**NOTICE TO CONTRACTORS**

**BID #1415-061**

**Sodium Hypochlorite Tank Replacement Project**

**Addendum No. 1**

# Fire Riser Location and #3 Water Plan

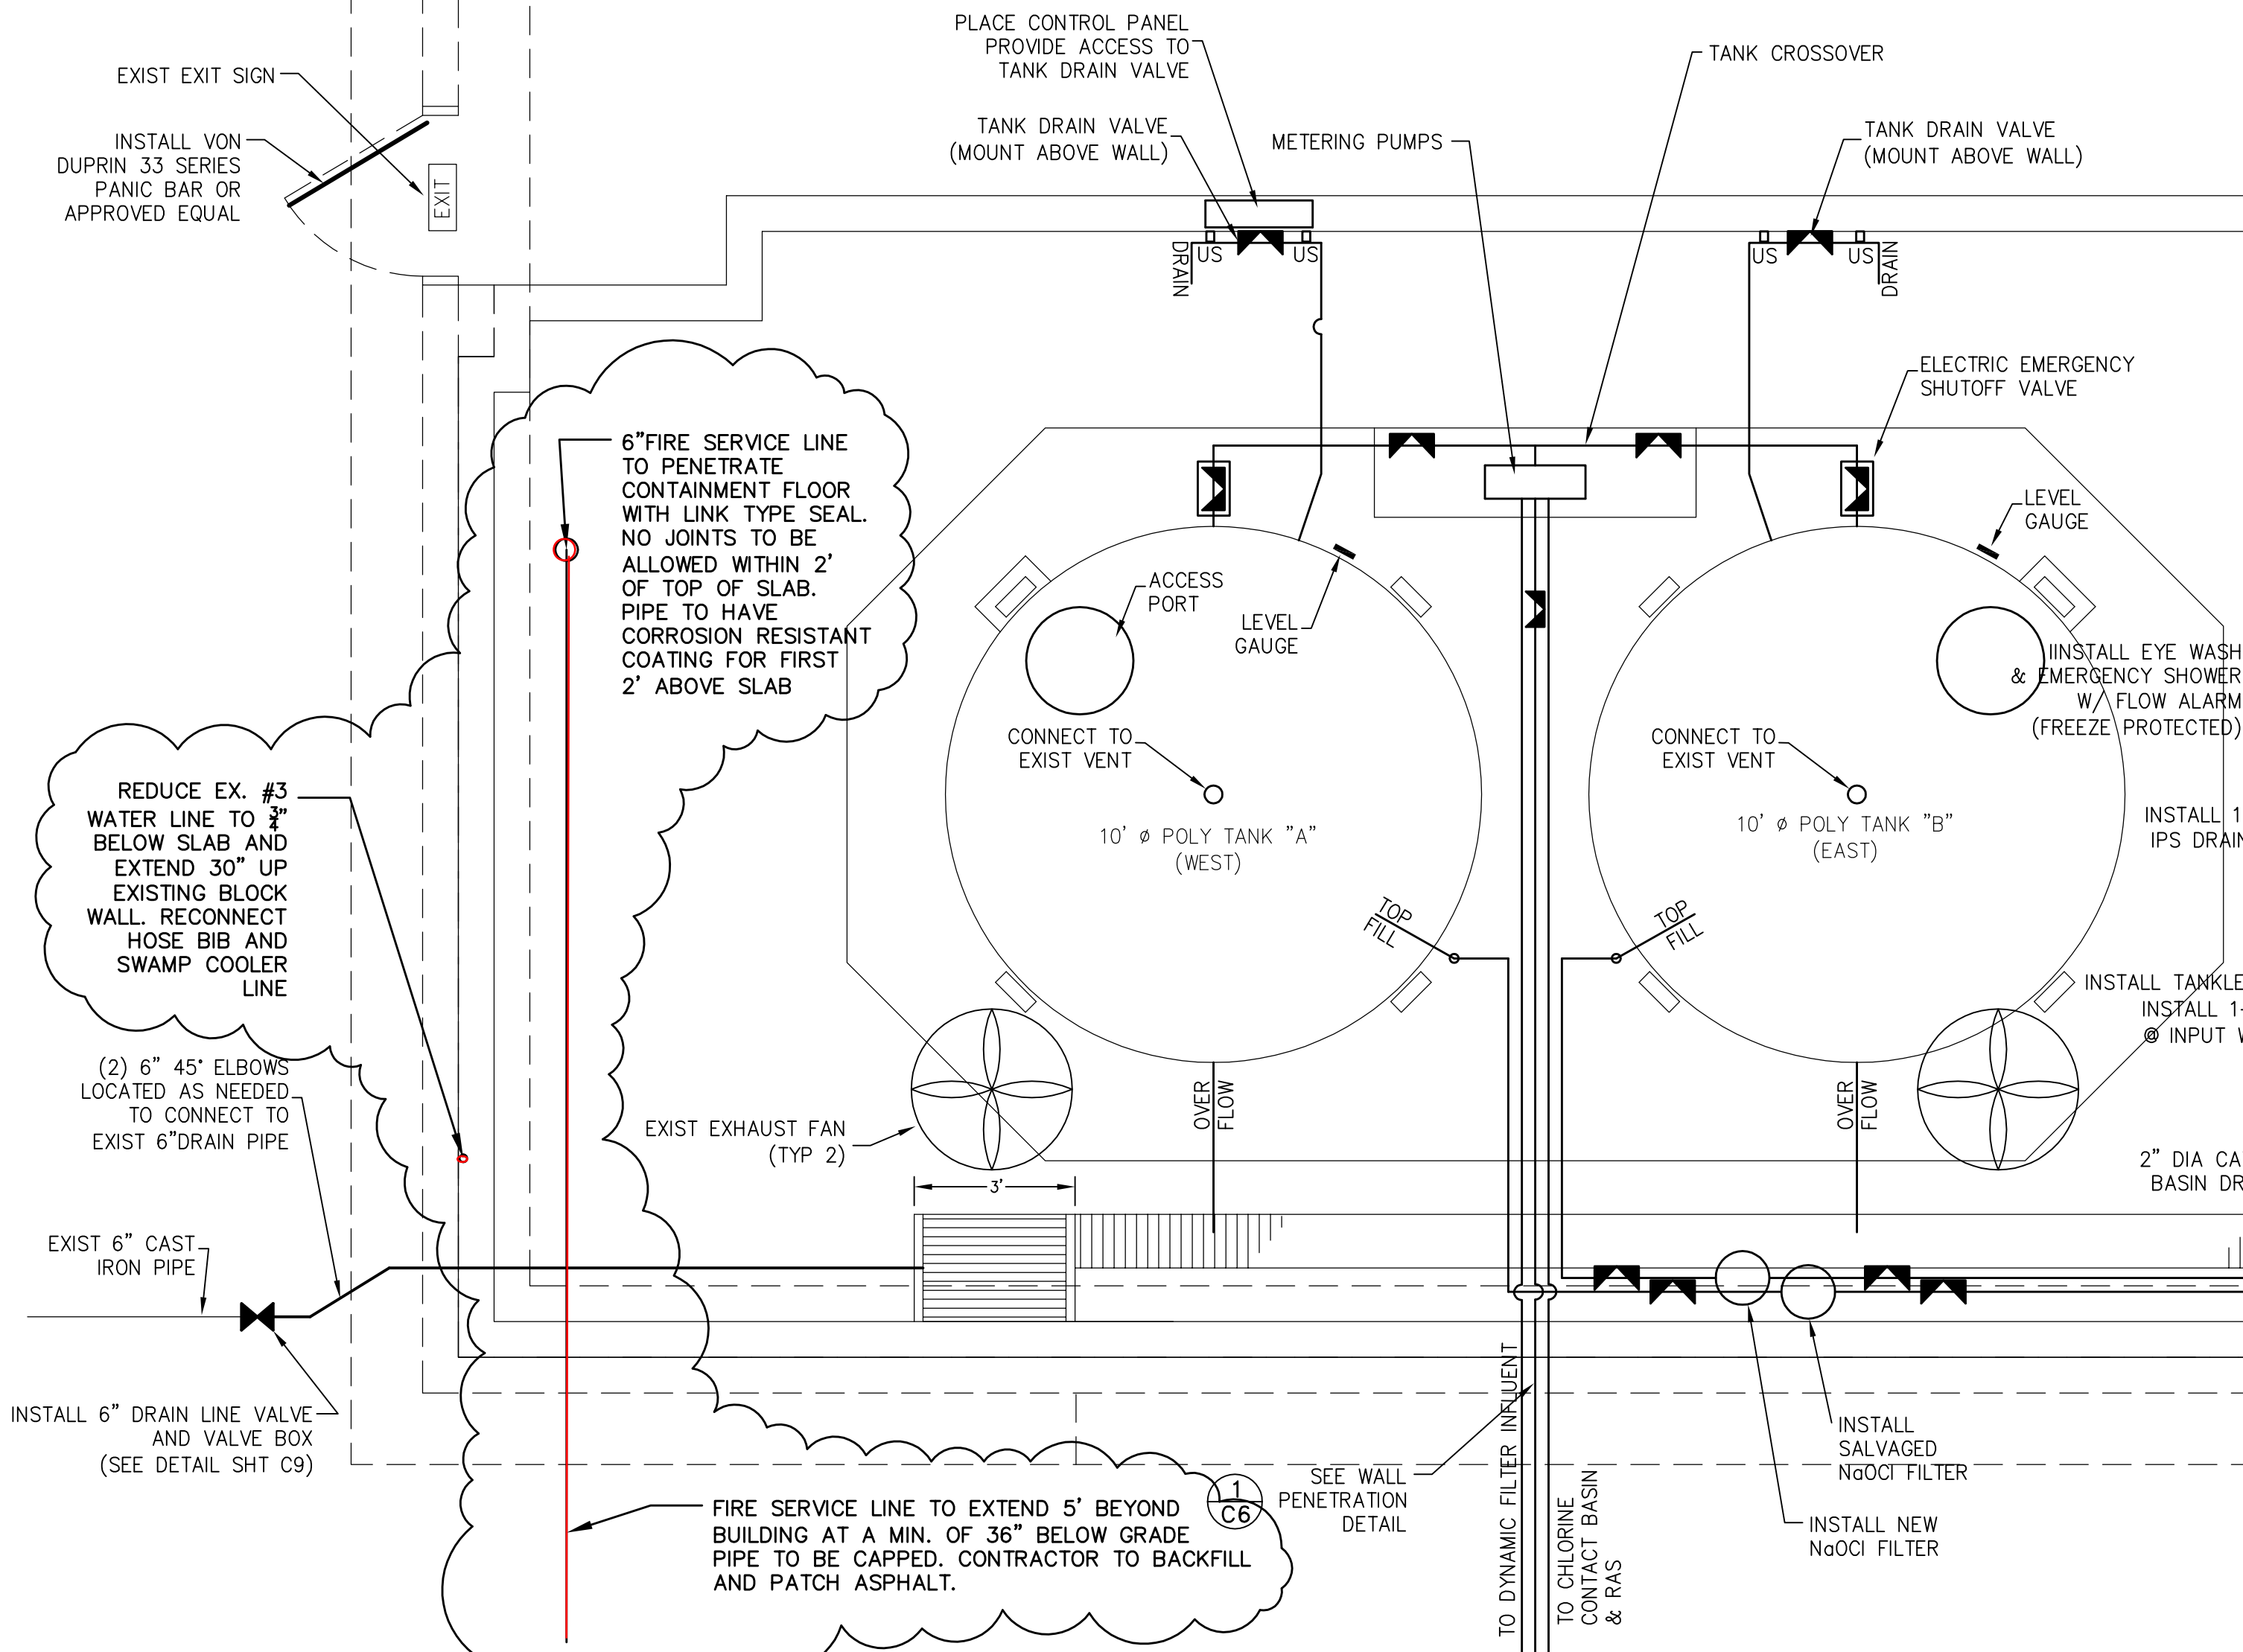
4. Information on the fire alarm and sprinkler system has been provided at the back of this addendum. A complete set of shop drawings it to be submitted and approved by the Carson City Fire Department. The fire alarm system and plumbing shall be included to the list of required submittals noted in the Special Conditions of the bid document. The fire sprinkler system will not need additional corrosion protection beyond what is typically provided excluding where the riser penetrates the containment floor as shown on the attached "Fire Riser Location and #3 Water Plan."

## Step 2 | Hardware migration: Seamless migration from the SLC500 controller and I/O to Modicon 340 control system

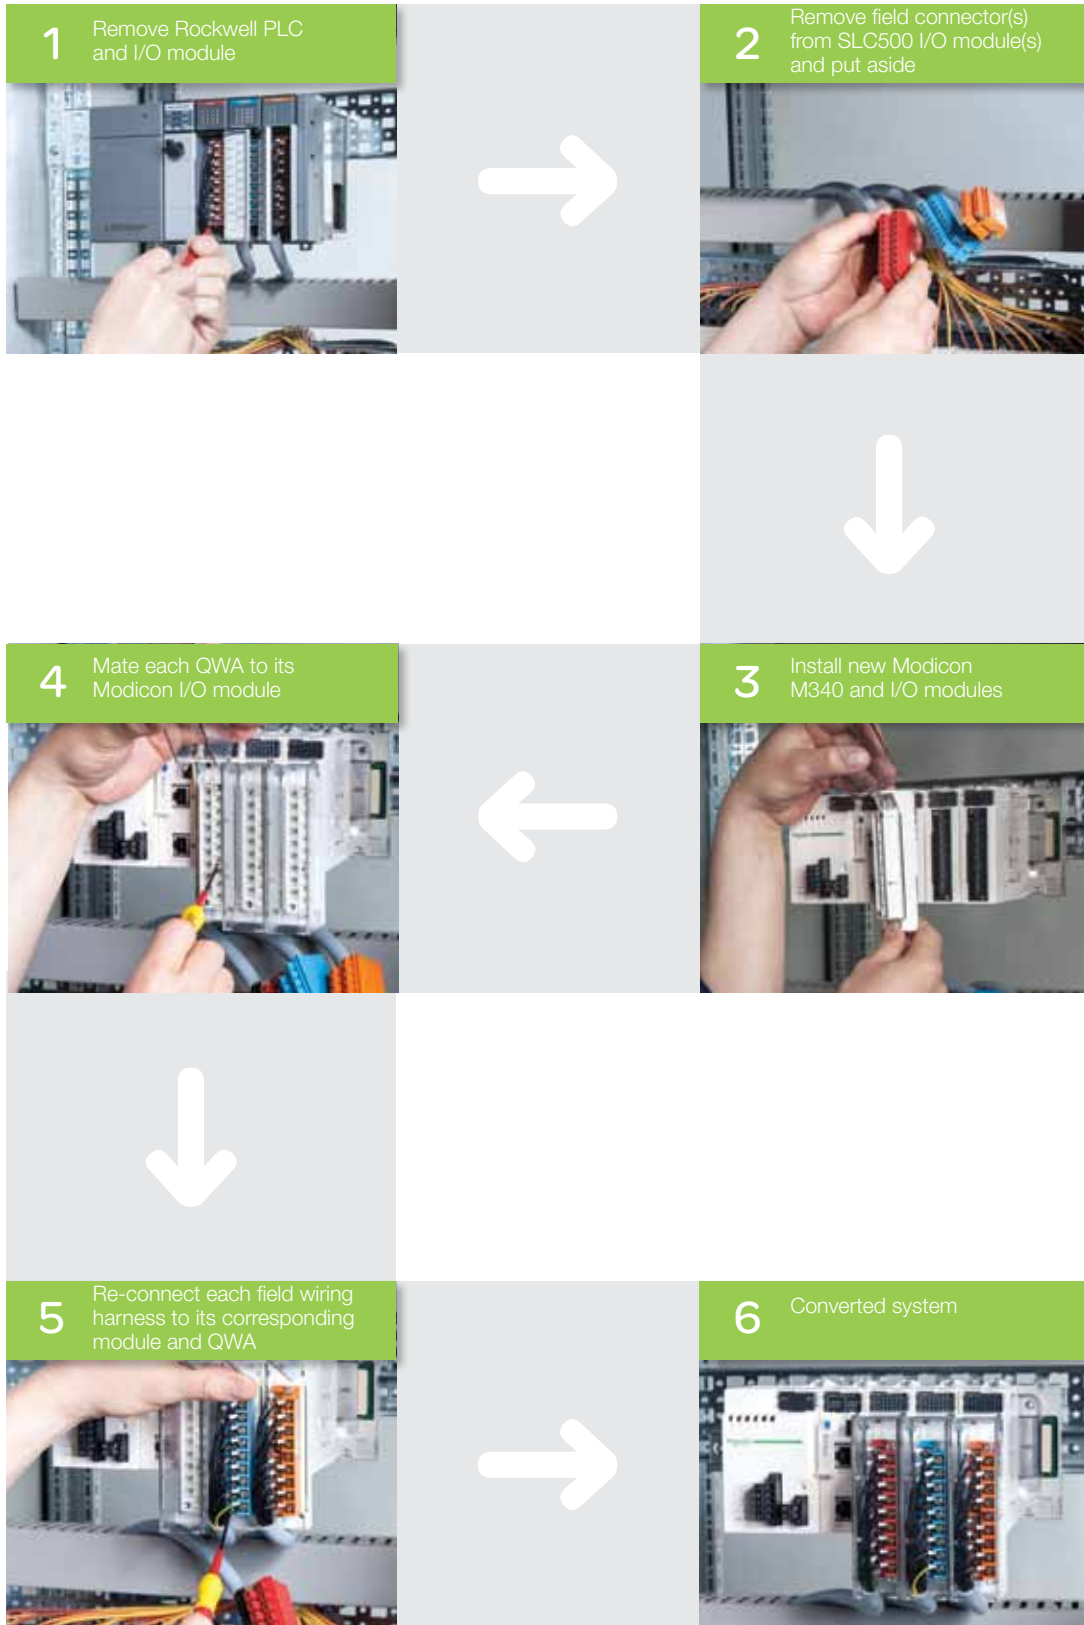
It is the City's intention that the PLC program be migrated using Schneider Electric software conversion tools as shown under step one of the Rockwell Migration Brochure included in this addendum. Additionally the hardware migration shall be performed using the Schneider quick wiring adapters as shown under step two of the attached brochure.
